MP 07_0006 - INNER WEST MARINA

**PROPONENT'S RESPONSE
TO SUBMISSIONS FROM AGENCIES AND THE PUBLIC**

3 MARCH 2011

Figure 2 – Extract from the Breakfast Point Masterplan 2002 – Nominated location for Marina Parking on site (subject Waterways, Planning NSW consent) for 100 spaces

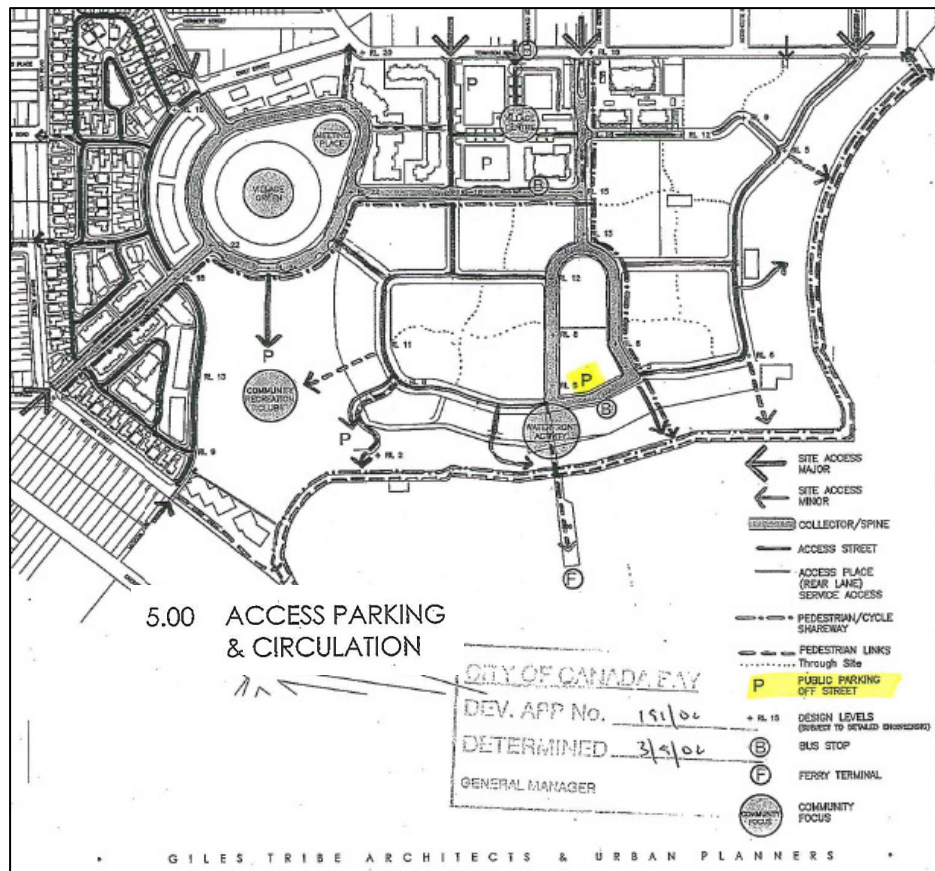
4.1.1 *A marina of this scale (172 berths) was not considered in the planning for the redevelopment of Breakfast Point.*

Figure 2 shows the nominated site access and location for the offstreet car parking associated with a “future marina (subject to Waterways and Planning NSW Consent).”

Therefore, whilst the water based uses were beyond the Masterplan area and subsequently the size and scale of any future marina was not detailed in the 2002 Masterplan, provision for the necessary land based support facilities was approved in the form of 100 car parking spaces expressly set aside for future marina car parking.

Figure 4 – Extract from the Breakfast Point Masterplan 2002 –Intensive Waterfront Area

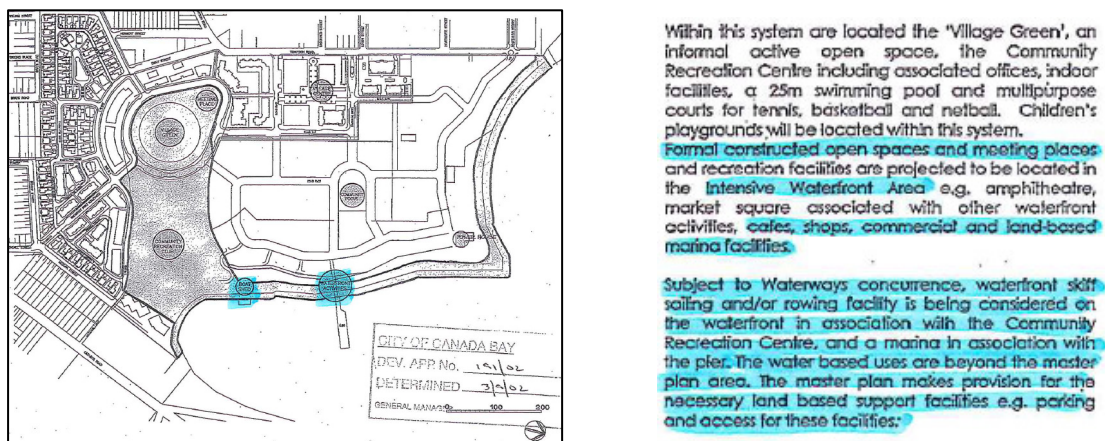
4.1.7 All editions of the Masterplan and Concept Plan leave off any picture of a marina

The water based uses (including skiff, sailing, rowing facility and marina in conjunction with the pier) were noted as being “*beyond the masterplan area*” as they would be located on land below MHWL owned by NSW Maritime, which was land outside of the Canada Bay LGA (**Figure 4**). Notwithstanding this, the Masterplan made provision for the necessary land based support facilities eg parking and access for these facilities (**refer Figure 2**).
